UNITED STATES PATENT AND TRADEMARK OFFICE

APPLICATION NO.	FILING DATE	FIRST NAMED INVENTOR	ATTORNEY DOCKET NO.	CONFIRMATION NO.
10/661,287	09/12/2003	Feng Chen	TI-35766 (032350:B524)	7460
23494	7590	07/26/2005	EXAMINER	
TEXAS INSTRUMENTS INCORPORATED P O BOX 655474, M/S 3999 DALLAS, TX 75265			WILLIAMS, HOWARD L	
			ART UNIT	PAPER NUMBER
			2819

<b>Office Action Summary</b>	<b>Application No.</b> 10/661,287	<b>Applicant(s)</b> CHEN, FENG	
	<b>Examiner</b> Howard L. Williams	<b>Art Unit</b> 2819

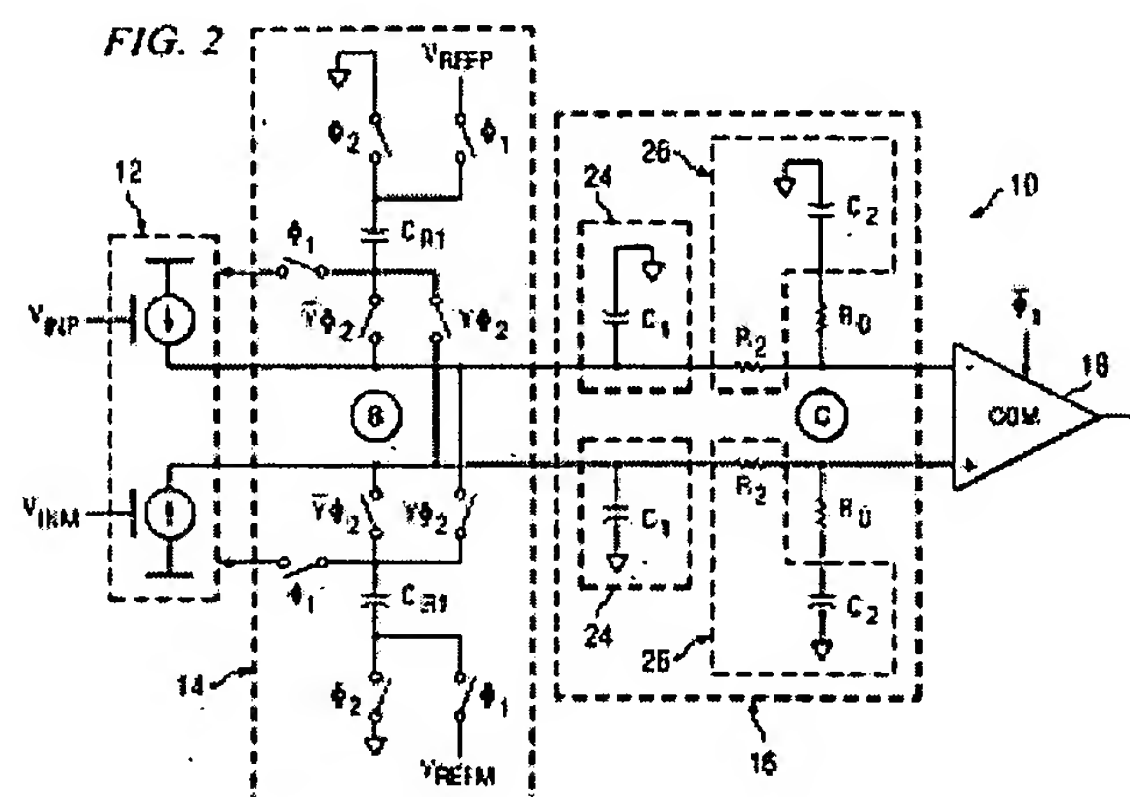
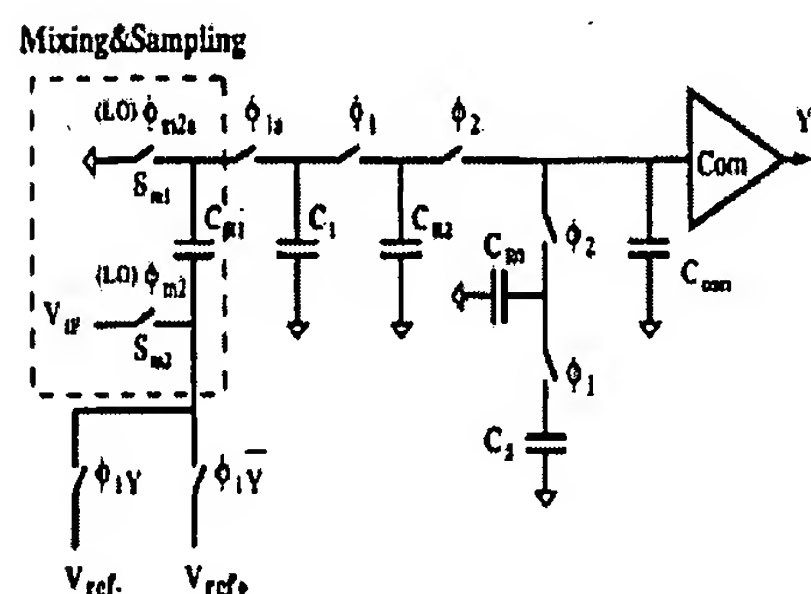
Benabes does not disclose the filters as active as the remarks imply. From the introduction one would not read the use of any amplifier associated with a filter. Benabe's goal it seems is to use passive filters. Benabes shows in his figure 2 a switch and hold element (as a box) which can be

readily implemented with a capacitor alone. Particularly where the goal is passive filters. Turning to the Chen article, it too shows passive discrete time feedback and a comparison with figure of the present application seems useful

While the Chen article uses a single line drawing and figure 2 shows differential the feedback in both appears quite passive and that even the reference characters for the elements are labeled similarly.
